PRIVATE PLAN CHANGE 104
HEARING REPORT
VOLUME I
79 LADIES MILE, REMUERA
FLETCHER RESIDENTIAL LIMITED

Reporting on proposed Private Plan Change 104 - 79 Ladies Mile, Remuera to rezone from Special Purpose – Major Recreation Facility zone to a combination of Residential – Terrace Housing and Apartment Buildings zone and Residential – Mixed Housing Urban zone.

Hearing Report for Proposed Private Plan Change 104: Remuera Precinct to the Auckland Unitary Plan (Operative in part)

Figure 1: Remuera Precinct Plan 3 – Movement Plan

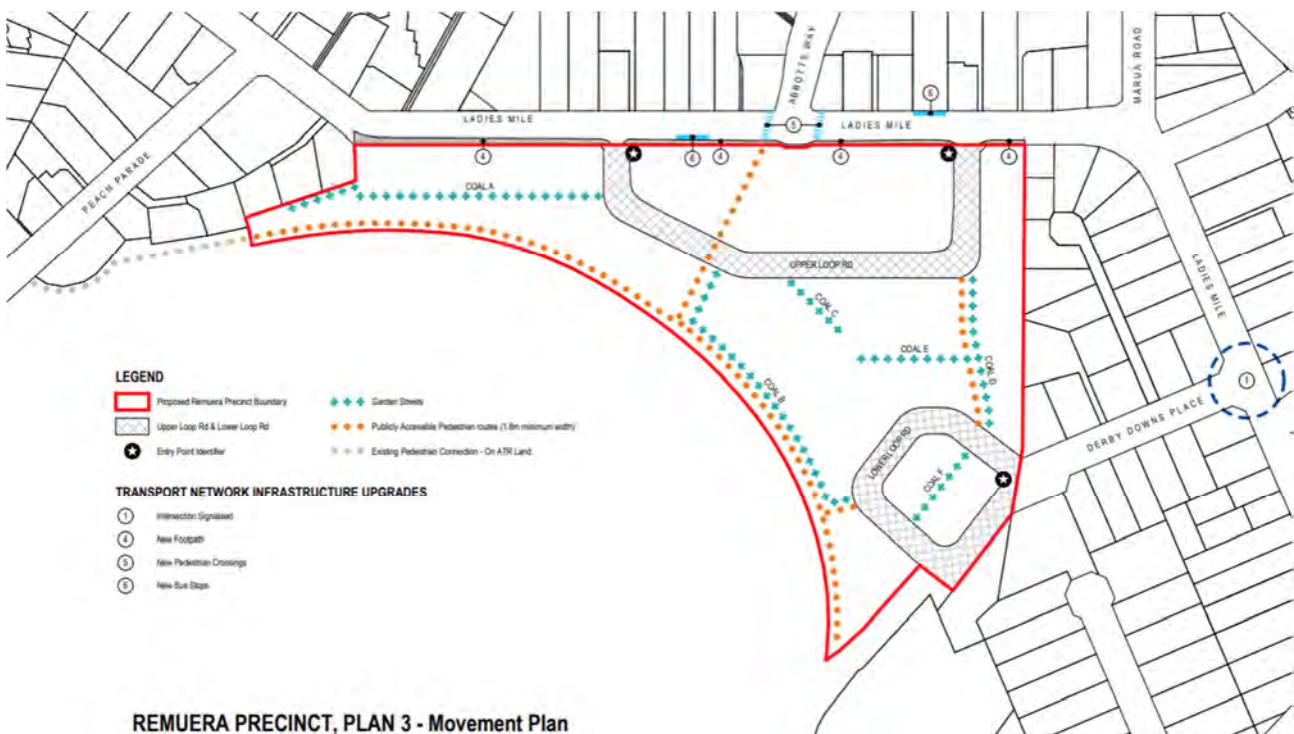
- ◆ Ladies Mile footpath upgrade along the site frontage
- ◆ Provision of a new northbound bus stop on Ladies Mile north of Abbots Way and relocation of the existing southbound Ladies Mile bus stop.

Figure 2: Existing slip lane that serves 82-88 Ladies Mile

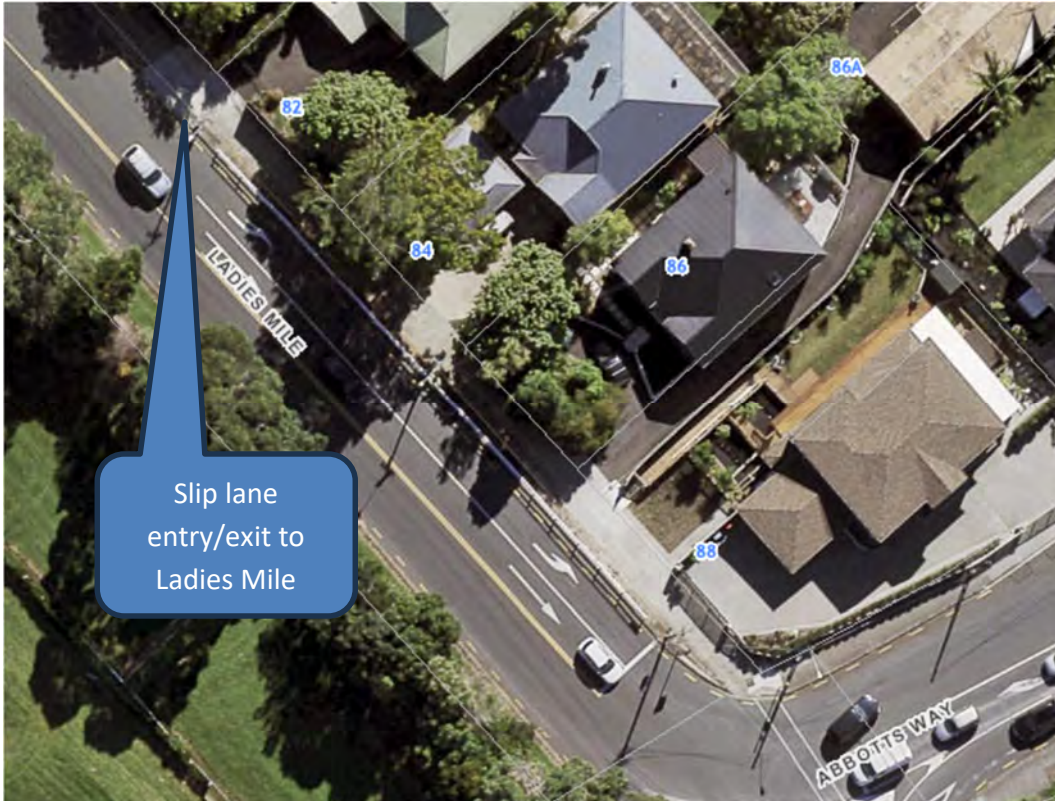
I have included an aerial view of the existing slip lane in Figure 2 below.

Figure 3: Approved Engineering Plan showing the flush median extent along Ladies Mile

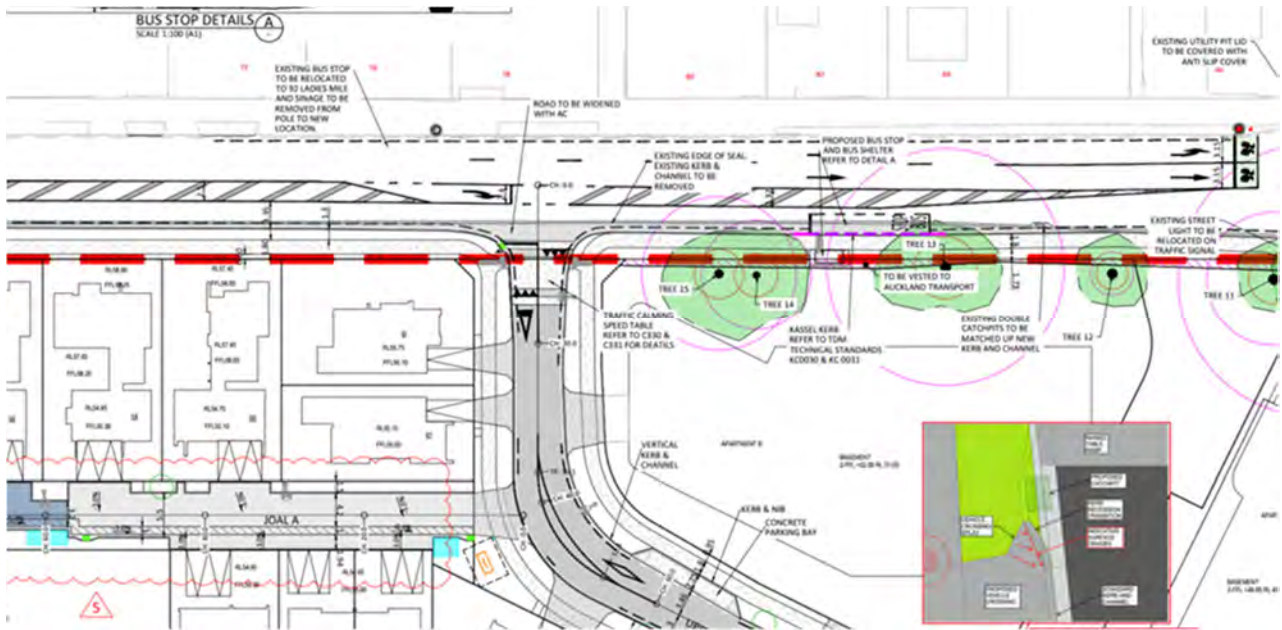
I have included a screenshot of the Approved Engineering Plans in Figure 3 below.

Figure 4: Existing slip lane barrier next to 82-88 Ladies Mile

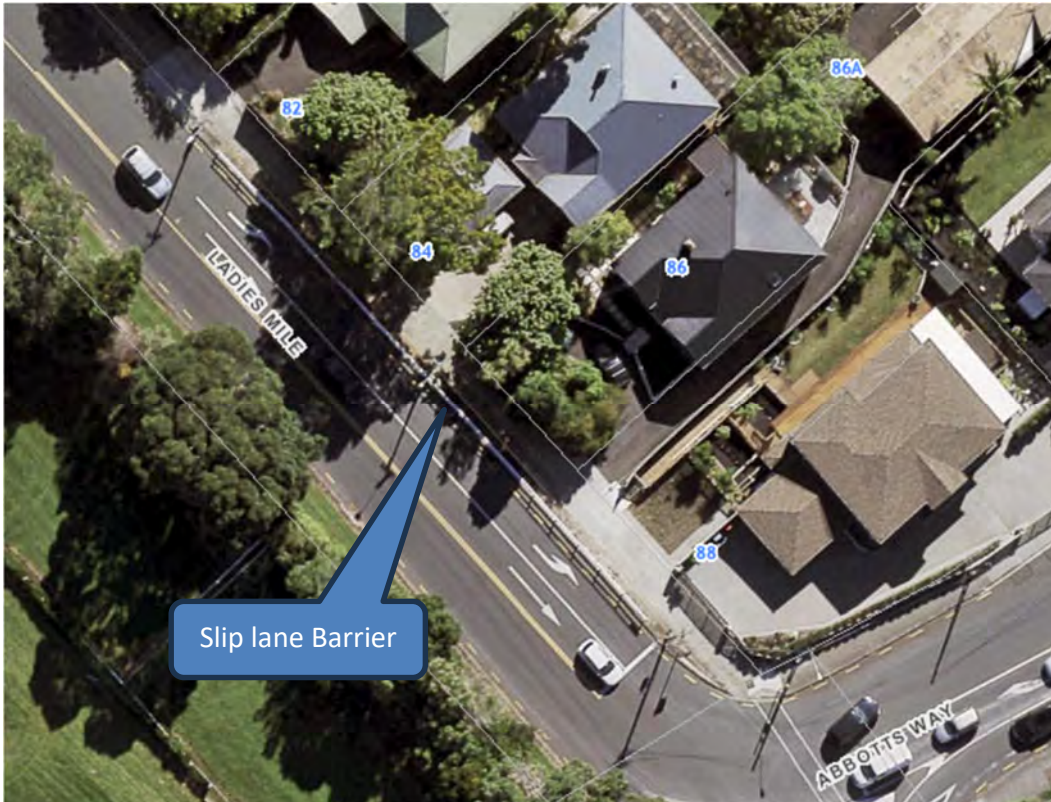
While I am not a safety barrier expert, I believe this is an existing issue rather than one directly related to the Plan Change. Further design details may address this concern, but it falls within the broader considerations for road safety at the detailed design stage of any development, and I consider this not to be a Plan Change issue. I have included an aerial view of the existing slip lane barrier in Figure 4 below

Figure 6. Flood prone areas, flood plains, overland flow paths, stormwater infrastructure and the PPC site circle in red, source Auckland Council GeoMaps, October 2024

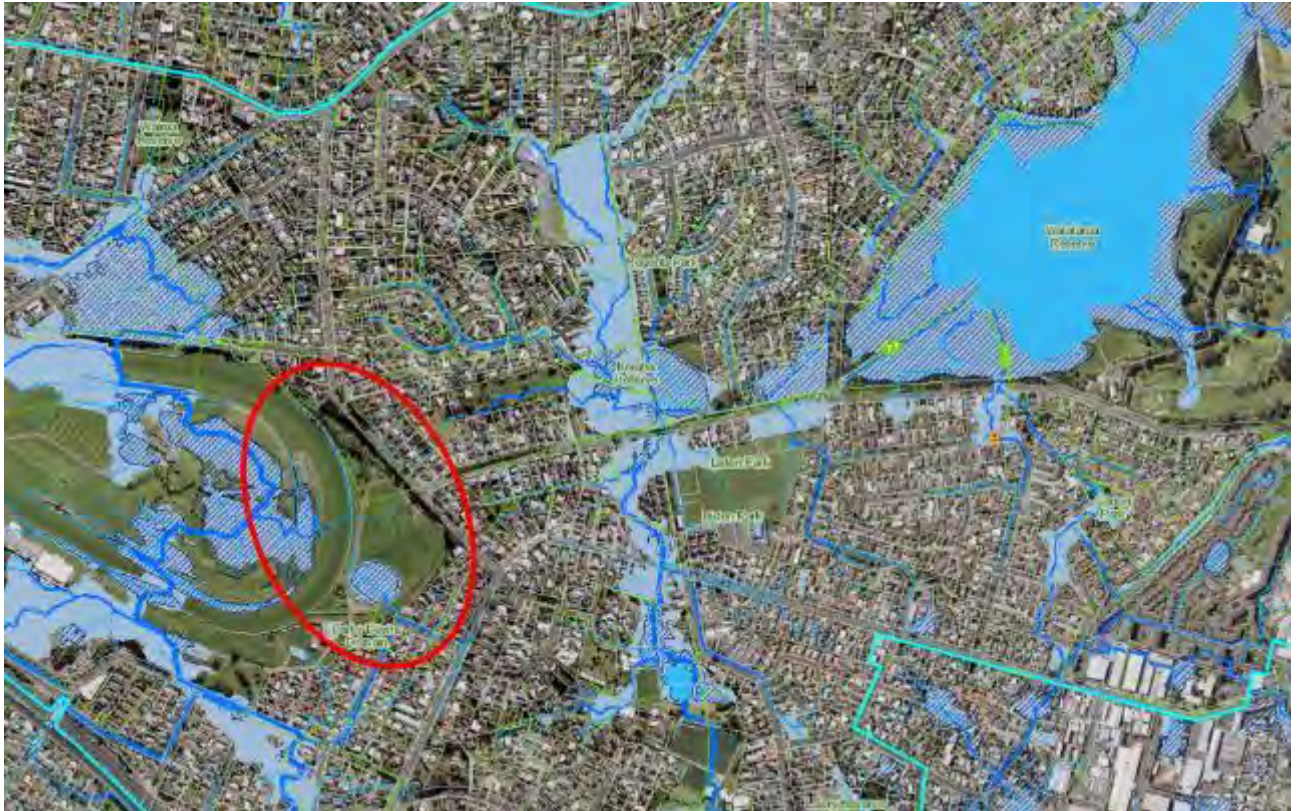
6.1 The site for the PPC is located in the Ellerslie catchment and discharges to the Waitemata. Figure 6 below shows the flood prone areas, flood plains, overland flow paths and stormwater infrastructure and devices for the PPC and the surrounding environment, including Waitatarua Reserve. While the site for the PPC has a flood plain, this is located over a now infilled stormwater irrigation pond. The flood plains shown for the Ellerslie catchment in GeoMaps have not been updated and are currently based on a 2021 model. There are overland flow paths on the site. The main overland flow path is along the western boundary and through the existing stormwater irrigation pond to Derby Downs Place.

Figure 2. IXXX10.3 Remuera Precinct Plan 3- Movement showing the connections within the proposed Remuera Precinct.

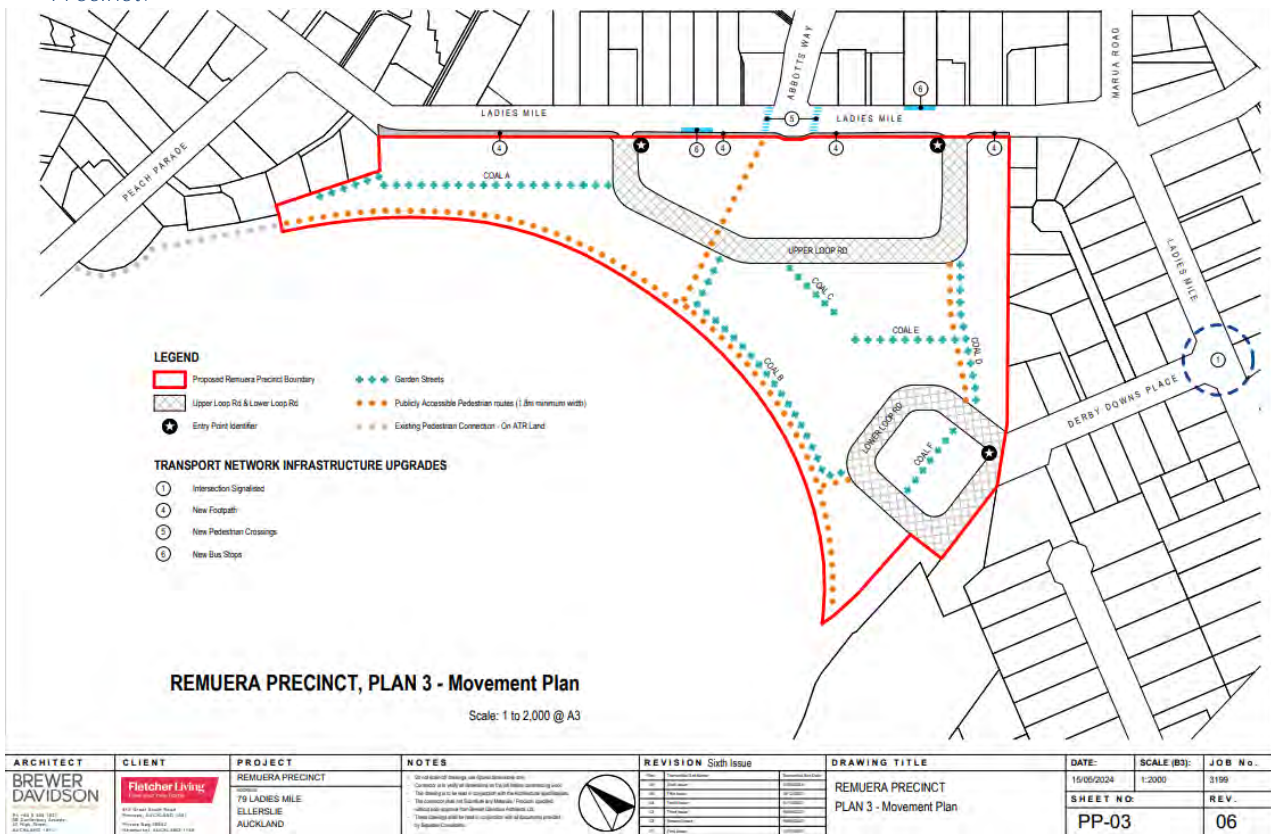
3.11 According to the connections shown on the proposed Movement Plan (see Figure 2) provided as Remuera Precinct Plan 3 by the Applicant, Garden Streets are proposed as (7-9m wide) COALs. Two Garden Streets are shown on this Plan as publicly accessible (provided for in the FT application via easements). These are along the Pedestrian Route connecting Upper Loop Road and Lower Loop Road, and between the Lower Loop Road and the Trackside walkway. Most Garden Streets however are proposed to provide private access to the residents with no public access proposed.

- 3.16 While the Movement Plan provided by the Applicant in PPC104 (Figure 2.) shows that these open spaces are bordered by a public road and a (1.8m min wide) **“publicly accessible Pedestrian Route”**, I consider a gap in the precinct plan provisions requiring for an appropriate interface between the site and those neighbouring open spaces. The proposed rezoning of those sites is a mixture of Residential-MHU and THAB zones where there is **no specific** requirement for boundary treatment along the shared boundaries with open space. Given the location and status of the Eilerslie Racecourse with a long-shared boundary with the subject site, I consider the proposed Remuera Precinct Plan as an opportunity to require for an appropriate shared boundary interface between the Eilerslie Racecourse and the proposed publicly accessible pedestrian route. In my view, relevant precinct provisions can ensure safe and attractive open space along a publicly accessible route where a (relatively) low height and permeable boundary treatment is to be provided along the shared boundary. The height of the fence must be low enough to provide for an attractive and visually interactive boundary but also high enough to meet the Health and Safety requirements associated to the user(s) of the racetrack (on Eilerslie Racecourse) versus the walkway (*publicly accessible pedestrian route*).

Figure 4. Snippet of Remuera Precinct Plan 2- Open Space & Features.

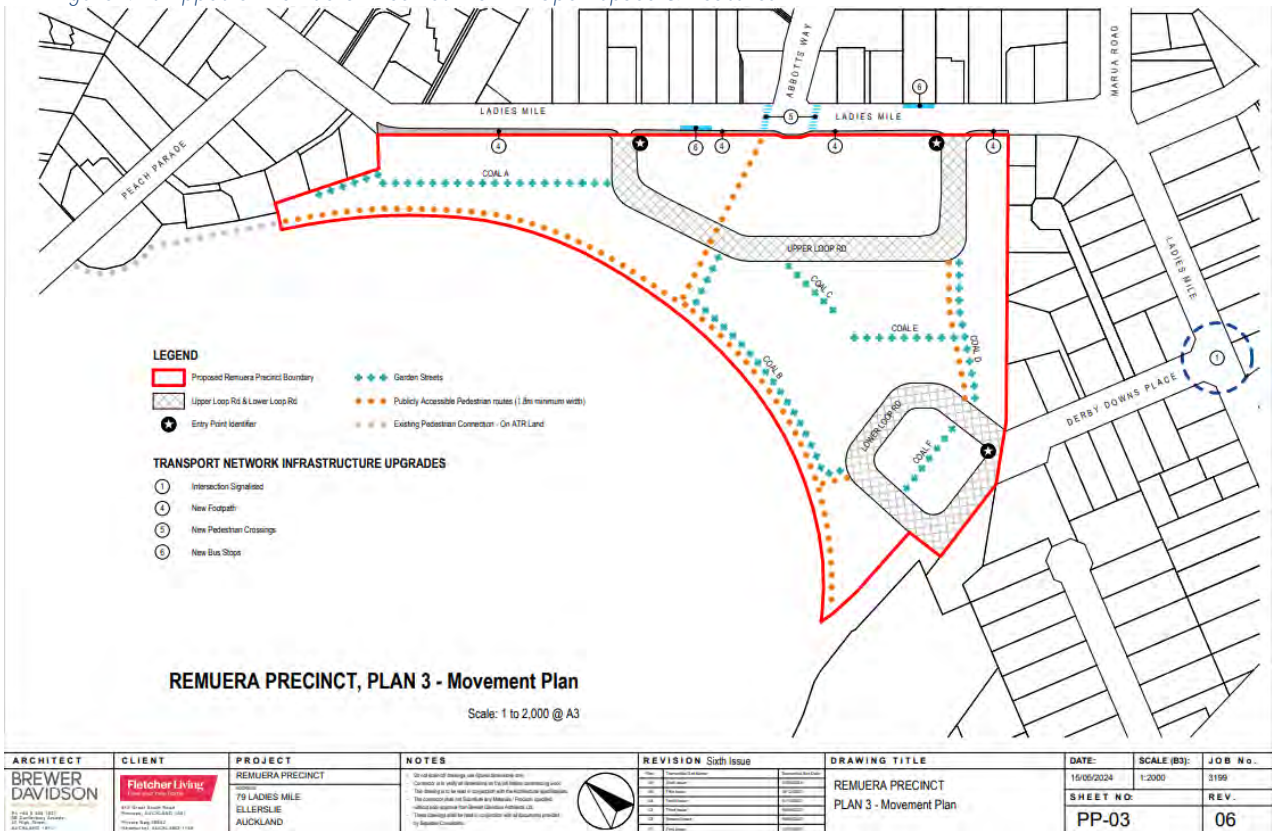
3.10 The Applicant also provided an open space plan within the proposed Remuera Precinct Plan referenced as IXXX.10.2 Remuera Precinct Plan 2 - Open Space & Features (Figure 4). The plan shows private (bright green) and public (dark green) open spaces. The public open spaces noted as “**publicly** accessible open **space**” are located along the shared boundary with the Ellerslie racecourse and noted as Trackside walkway. Another strong publicly accessible open space is provided from Ladies Miles through the centre of the development to the racecourse, noted as Belvedere Garden East and West. These along
